NZ 182/05 NORTH & SOUTH PACIFIC– Miscellaneous Corrections.

Chart NZ 14052 (INT 52) [158/05]

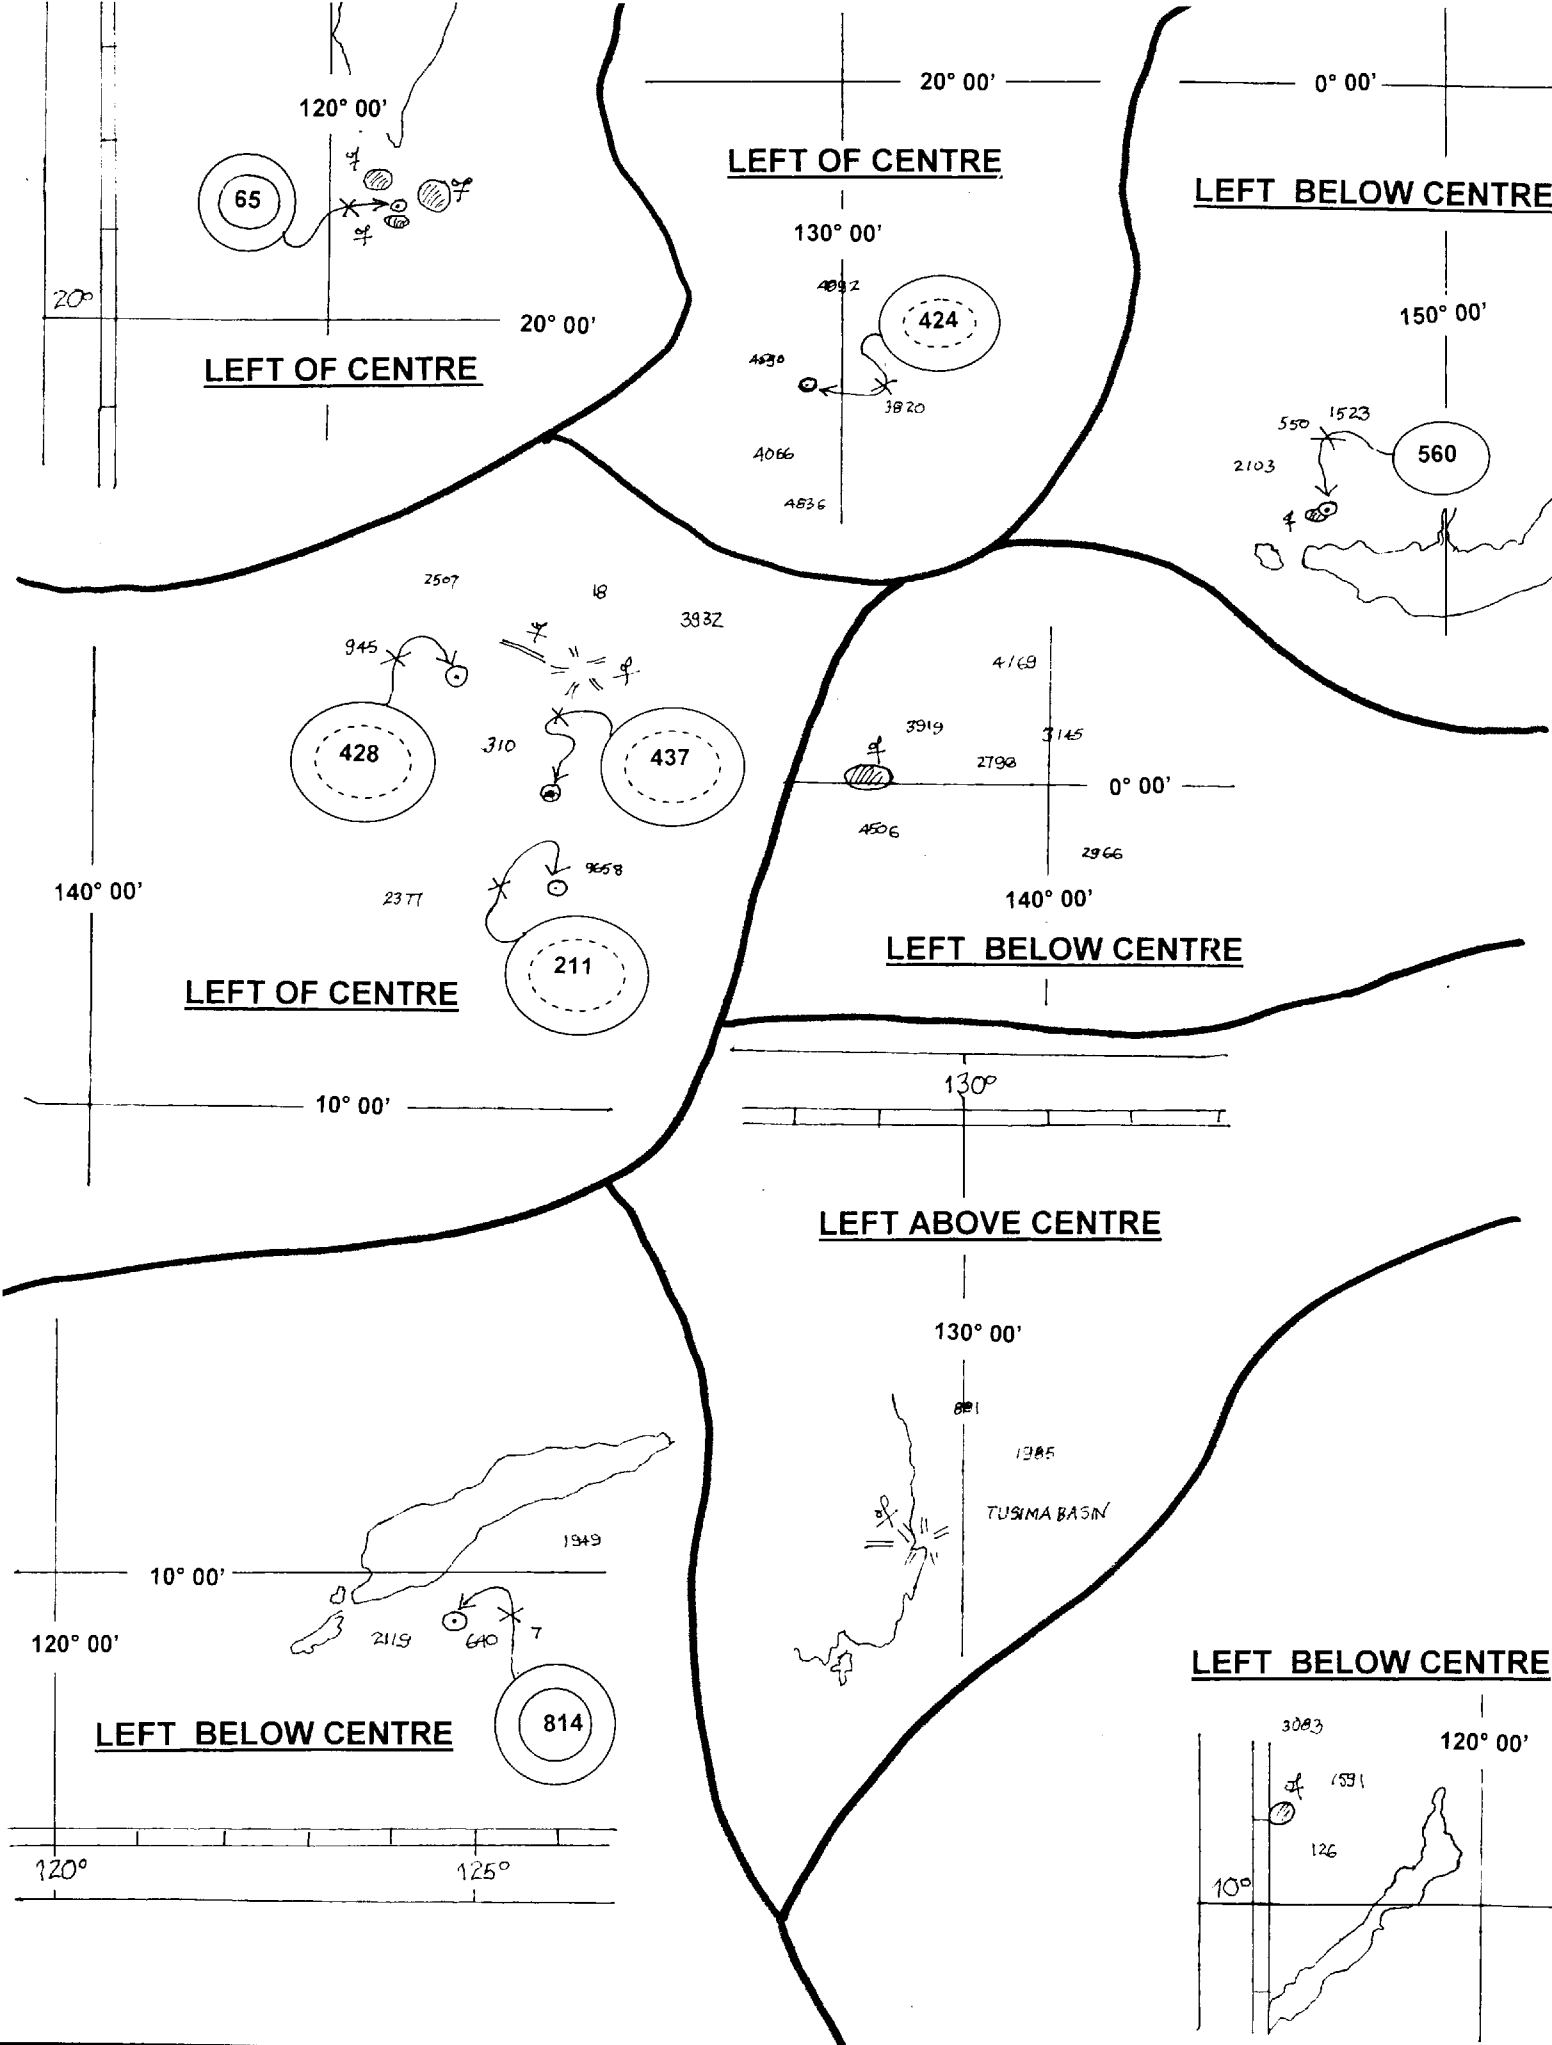
Insert	depth 65 enclosed by a contour	(a) 21° 12'N.,	120° 51'E.
	depth 424 enclosed by 	16° 32'N.,	129° 37'E.
	depth 428 enclosed by 	15° 00'N.,	144° 17'E.
	depth 437 enclosed by 	13° 41'N.,	145° 30'E.
	depth 211 enclosed by 	12° 37'N.,	145° 31'E.
	depth 814 enclosed by a contour	10° 37'S.,	124° 45'E.
	depth 560	(b) 5° 09'S.,	148° 35'E.
Delete	radiobeacon, RBn	36° 05'N	129° 34'E.
	radiobeacon, Aero RC	15° 10'N.,	145° 43'E.
	ODAS buoy	0° 03'N.,	137° 52'E
	depth 15 ₈ and enclosing 	21° 35'N.,	120° 34'E.
	depth 20 and enclosing 	21° 25'N.,	121° 19'E.
	depth 41		close S. of (a).
	rock and enclosing 	11° 02'N.,	117° 39'E.
	depth 759		close W. of (b)
